# Mike Turtur Bikeway Overpass Project Community Reference Group Report

- This document provides an overview of the Mike Turtur Bikeway Overpass (MTBO) project Community Reference Group (CRG) process and a summary of the insights shared by CRG members.

# Option 3 – New underpass (a - straight or b - curved eastern ramp)

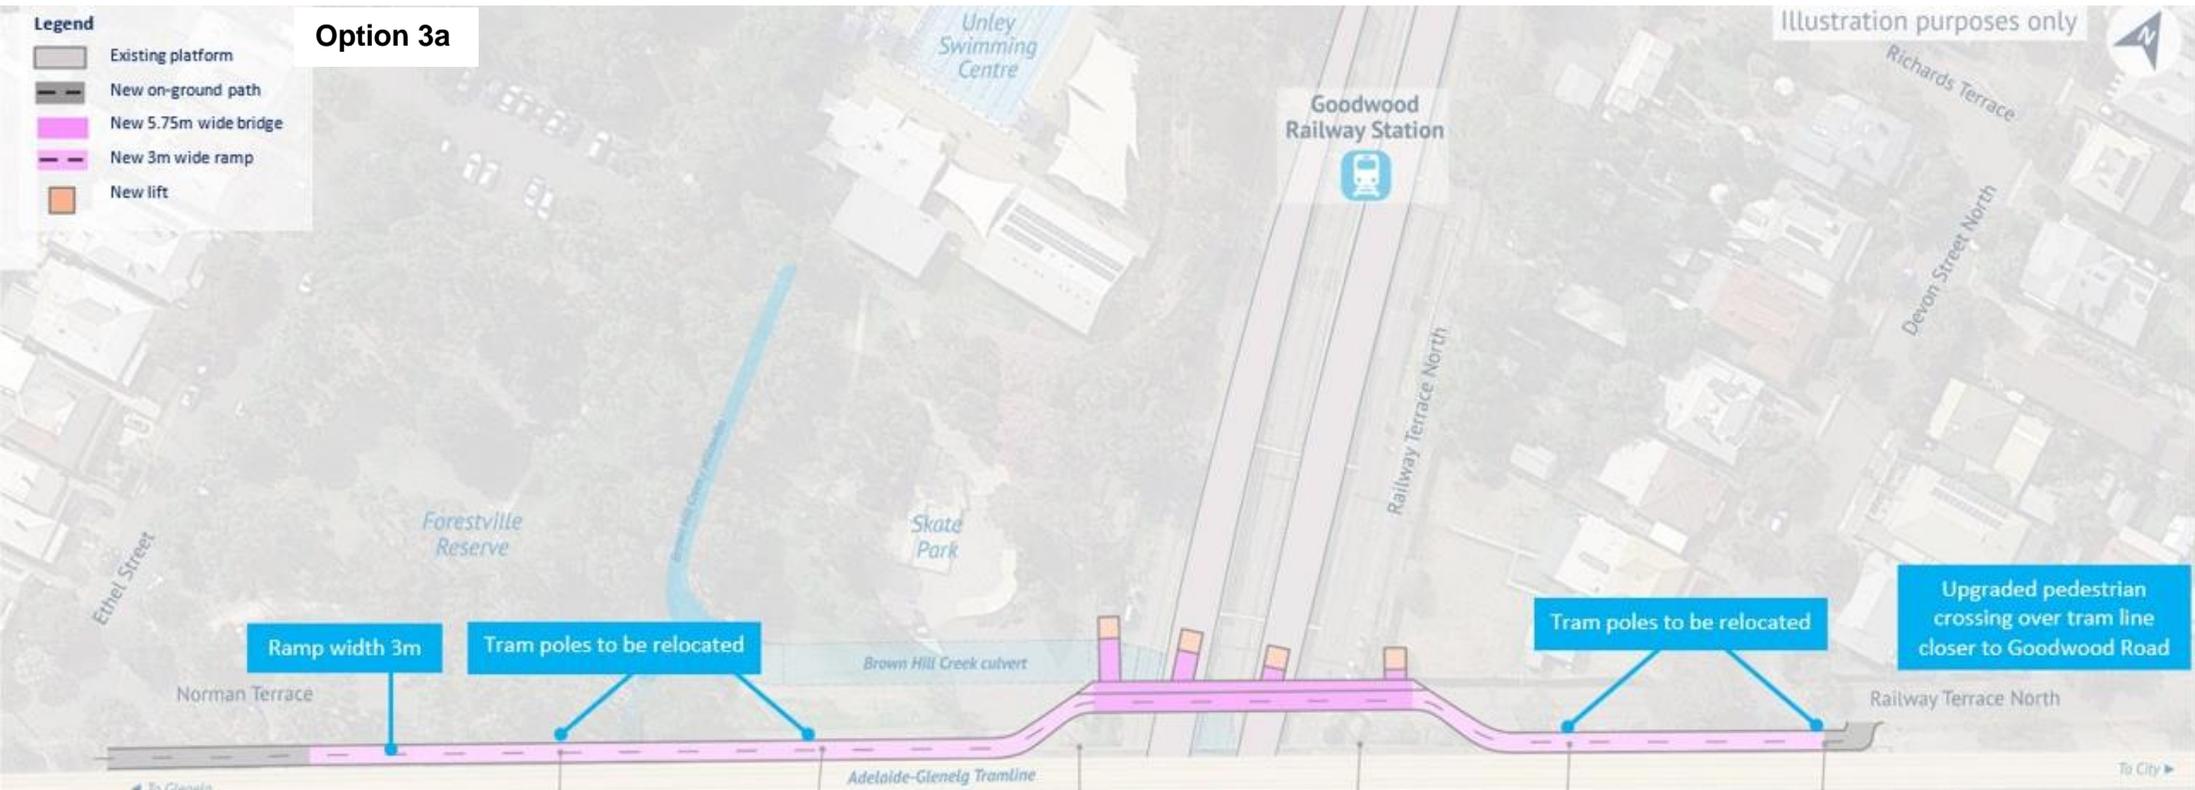
Strengths	Weaknesses
Reduced impact to reserve given it abuts the tram line (post construction)	Construction impacts in reserve and residents
Option for cyclists to use Railway Terrace North or South and therefore may reduce archway use	Tree impacts, including impact on significant tree on Devon Street North with straight ramp
Reduced visual impact on neighbouring property with straight ramp (further away from homes)	Less likely to be used by Marino Rocks Greenway cyclists with straight ramp as connectivity between routes is compromised
Straight route for Mike Turtur Bikeway users and potential to ease cross-overs between Marino Rocks Greenways commuters and Mike Turtur Bikeway users (on western side)	Surrounding local road network too narrow to cater for additional cyclists and already existing car, pedestrian and cycle interface risks
Improved sightlines and flow with straight ramp	Length of walkway to elevators (due to culvert location) and visual impact of elevator shafts

Four elevators all on the same side removes the conflict on the bridge, separates users and provides good DDA access	Bridge separated from tram overpass (due to culvert) has negative visual impact and creates a ‘dog leg’ in the path
Opportunity to increase vegetation and create eastern “pocket park” on Devon Street North, with clear open sight lines into park	Dark area created under bridge as no light can come in from the south, CPTED concerns, and no trees can be planted under ramps
Good line of sight for all users	Potential dangers at exits from descending cyclists travelling at high speeds
Perceived lower construction impacts	Impacts to tram services during construction and pole relocation
Option to relocate ball court to under the overpass	Requires new automated crossing towards Goodwood Road which will create noise for residents and increased wait times for cyclists
Most of the trees proposed to be removed are between 7-10 years old and will readily grow back	Elevators may be undesirable to use

Overlooking and light spill into nearby residential properties
	Visually intrusive large structure in reserve

Strengths	Weaknesses
Reduced impact to reserve given it abuts the tram line (post construction)	Construction impacts in reserve and residents
Good connection for Marino Rocks Greenways cyclists	Length of walkway to elevators (due to culvert location) and visual impact of elevator shafts
Good line of sight for all users	Tree impacts in reserve
Direct access to Railway Terrace South	Bridge separated from tram overpass (due to culvert) has negative visual impact and creates a 'dog leg' in the path
"Pocket park" inside of curved ramp, can offset tree loss and provide open area	Surrounding local road network too narrow to cater for additional cyclists
No impact to significant tree on Devon Steet North	Visual impacts of large concrete structure and elevator shafts in reserve and at the end of Devon Street North
Four elevators all on the same side removes the conflict on the bridge, separates users and provides good DDA access	Dark area created under bridge as no light can come in from the south, CPTED concerns, and no trees can be planted under ramps

Option to have a reverse curve ramp on eastern side for improved visual amenity and access	Overlooking and light spill for neighbouring property
Option to relocate ball court to under the overpass	Curved ramp perceived as less safe than straight; perceived to be less visually appealing
Most of the trees proposed to be removed are between 7-10 years old and will readily grow back	Impacts to tram services during construction and pole relocation
	Possible impact to significant tree on Devon Street North during construction
	Conflict point at tram archway

# Option 4 – Southern Overpass

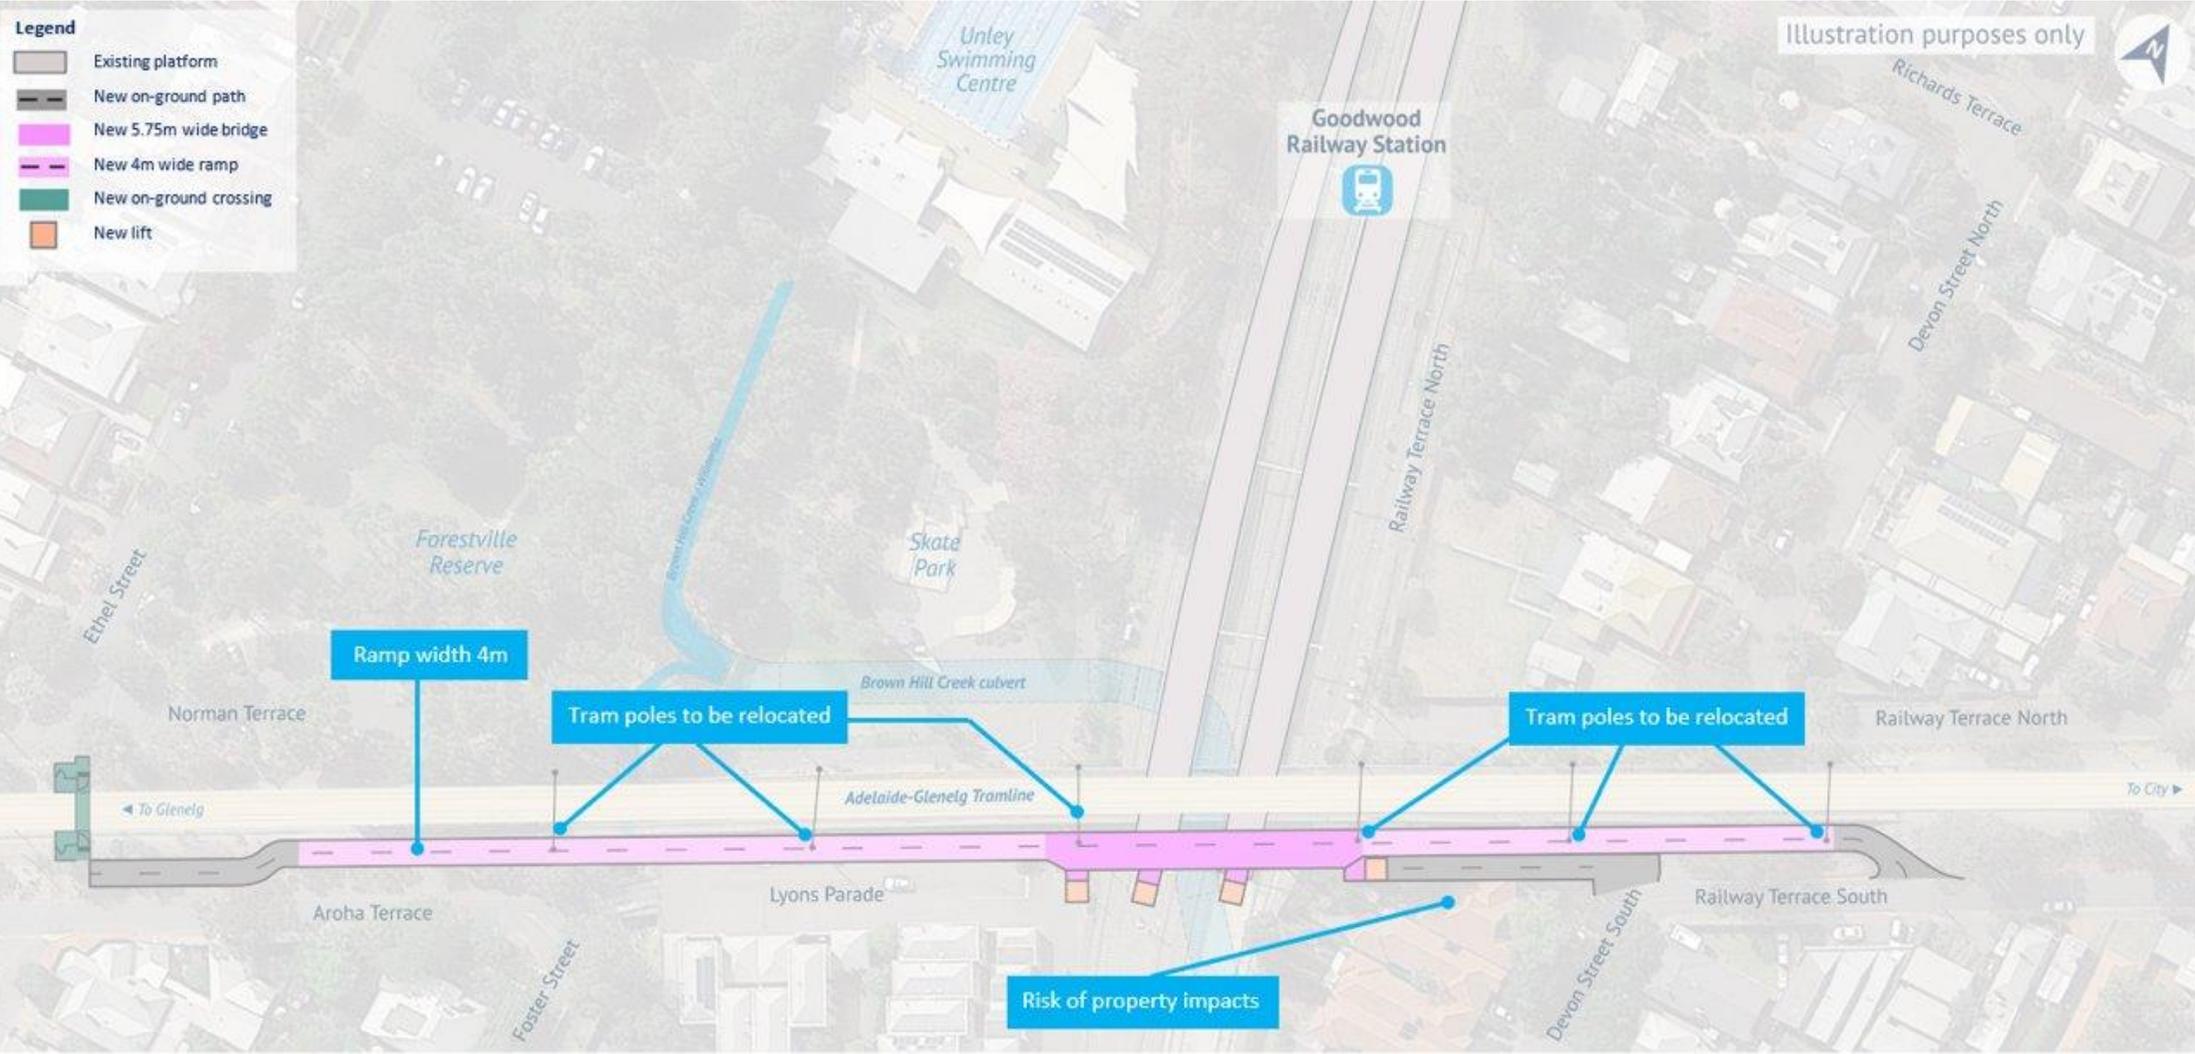
Strengths	Weaknesses
No impact to reserve during or post construction	Dark area created under bridge and shadowing increased into adjacent homes
Impacted trees are outside of the reserve area	Overlooking and visual impacts for a number of neighbouring properties
Reduces the conflict through the eastern tram archway	Impacts to tram services during construction and pole relocation
Good line of sight and flow with straight ramps	Mike Turtur Bikeway cyclists need to cross tram line via activated crossing, increased wait times
Four elevators all on the same side removes the conflict on the bridge, separates users and provides good DDA access	Addition of activated crossing over tram line at Norman Terrace and Ethel Street which is already a dangerous corner
Opportunity to increase vegetation in eastern "pocket park" on Devon Street North	Possible loss of eastern side "pocket park" (at Devon Street North) if not used for project

Potential to avoid narrow Norman Terrace and use wider Aroha Terrace	Poor connection for Marino Rocks Greenways cyclists

**Option 5b – Cycle only overpass on southern side, DDA access short overpass on northern side** (added at CRG meeting 4, CRG scoring was carried out on the hand drawn version. See next page for designed version

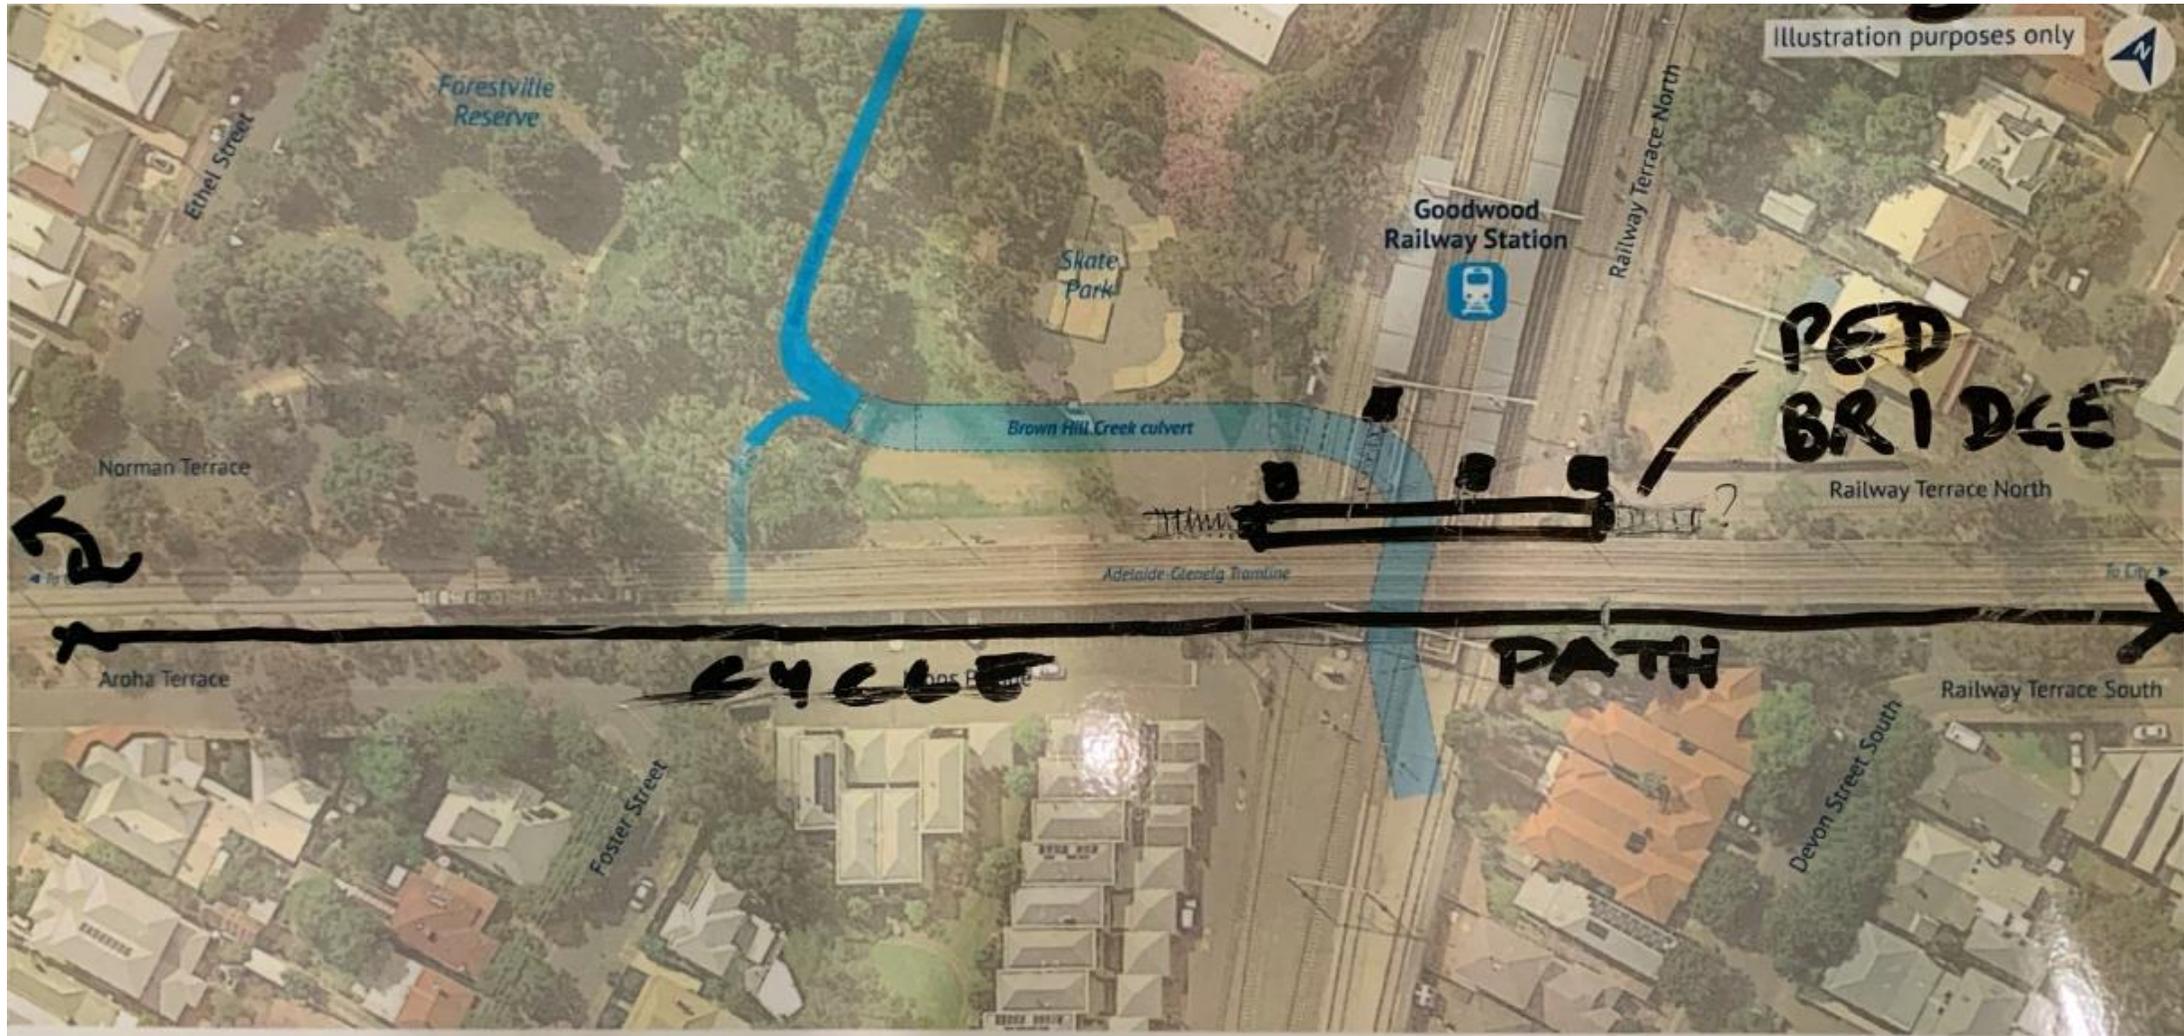
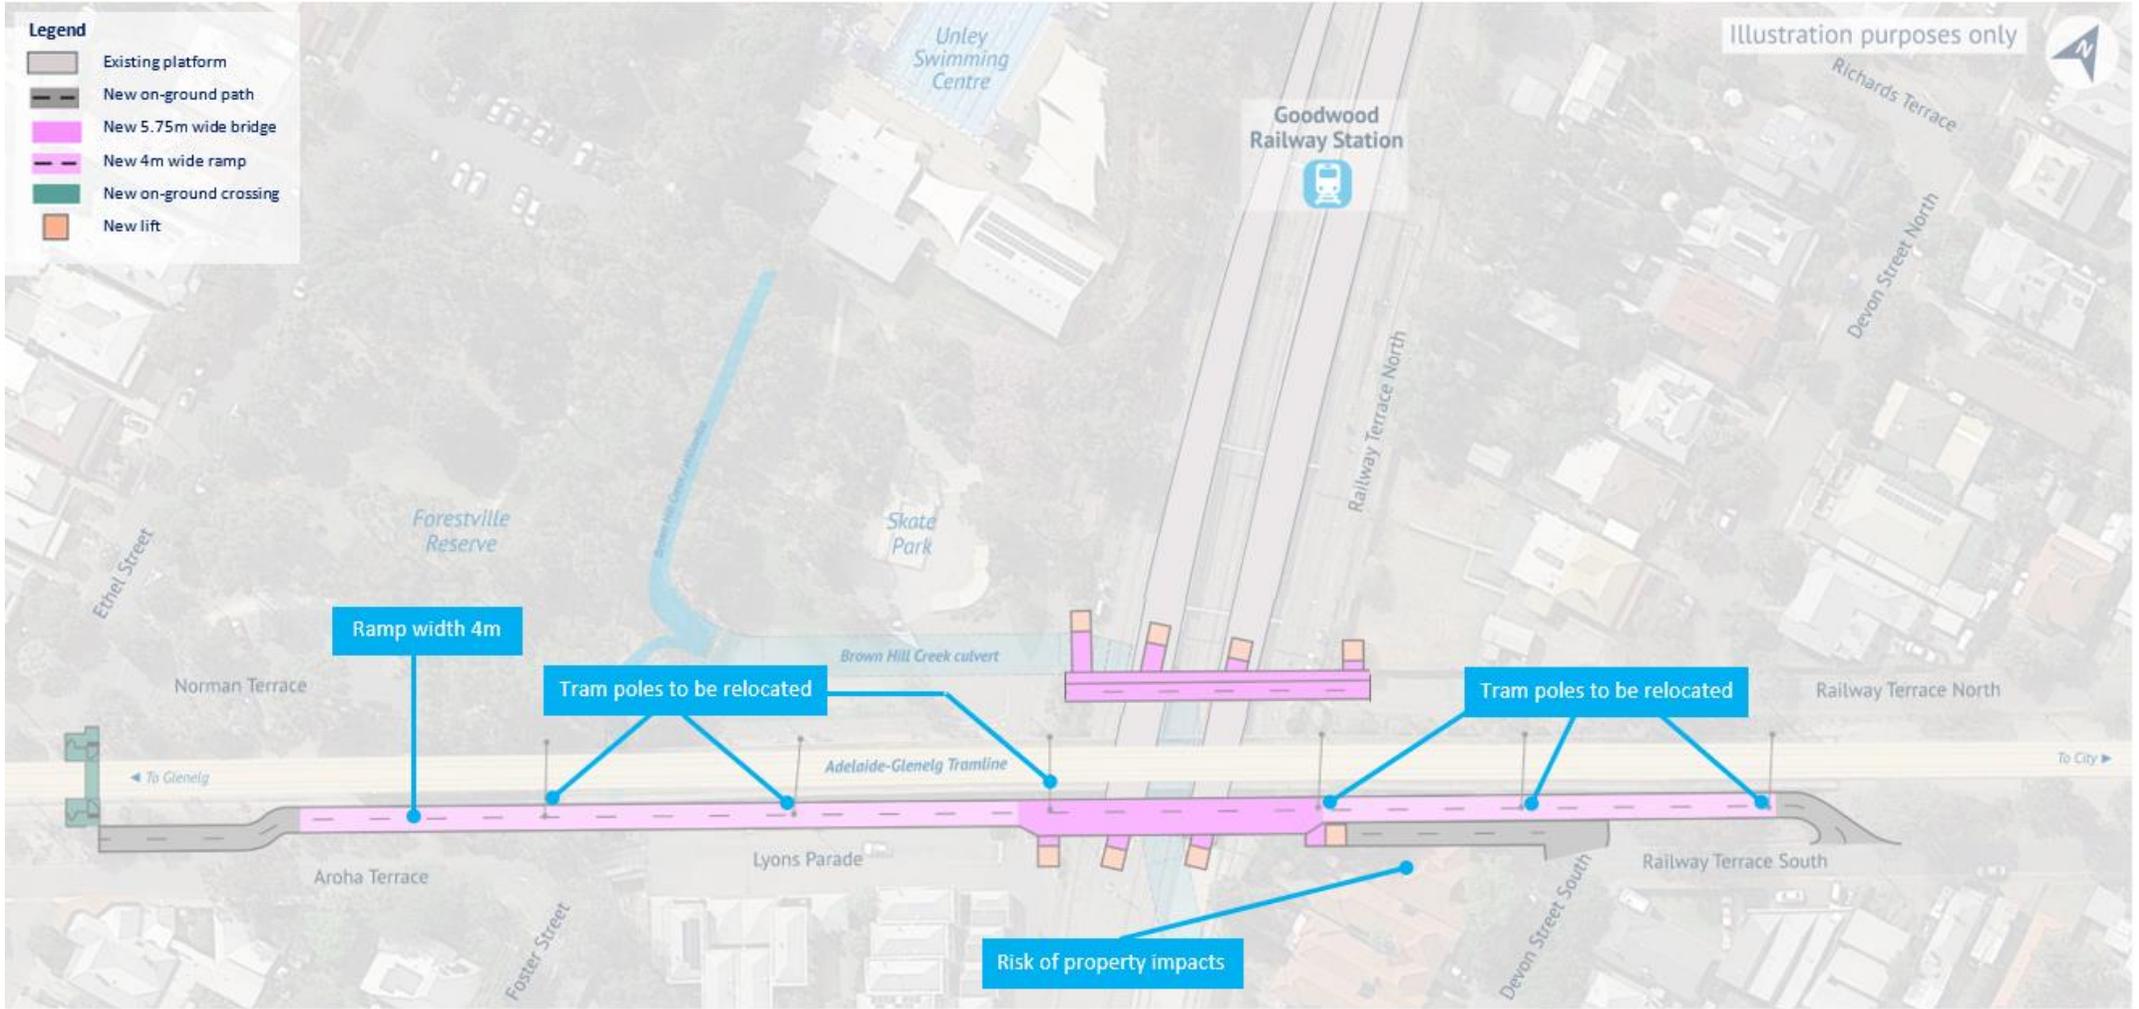
Strengths	Weaknesses
Reduced impact in reserve post construction	Overlooking and visual impacts for a number of neighbouring properties
Reduced conflict between cyclists and station access and provides good DDA station access	Increased cost, highly unlikely to be delivered within budget
Good line of sight with straight ramps for cyclists	Can't control cycle only, needs to be designed as Shared Use Path
Elevators located within the reserve area for increased passive surveillance	Dark area created under bridge and shadowing increased into adjacent homes
Impacted trees outside of the reserve area	Impact to both north and south side during and post construction
Reduced conflict through the eastern tram archway	Impacts to tram services during construction and pole relocation
Opportunity to increase vegetation in eastern "pocket park" on Devon Street North	Poor connection for Marino Rocks Greenways cyclists

Provides straight link for Mike Turtur Bikeway users with straight line of sight	Mike Turtur Bikeway cyclists need to cross tram line via activated crossing, increased wait times
Potential for cyclists to avoid narrow Norman Terrace and use wider Aroha Terrace	Addition of activated crossing over tram line at Norman Terrace and Ethel Street which is already a dangerous corner
Only minimal car park loss	Surrounding local road network too narrow to cater for additional cyclists with level crossing at Ethel Street. Railway Terrace South already very busy
	Possible loss of eastern side "pocket park" (at Devon Street North) if not used for project
	Cyclist removed from reserve, less passive surveillance and activity in the reserve
	Car park loss on Aroha Terrace and Lyons Parade
	Impacts to residents during construction
	Tree removals on north and south side
	Tree removals required in reserve for construction access (similar number to 3a)

Length of walkway to elevators (due to culvert location) and visual impact of elevator shafts

\*It is noted by PTP Alliance that this design will impose significant cost pressures to the current budget and is highly unlikely to be delivered within the current budget.
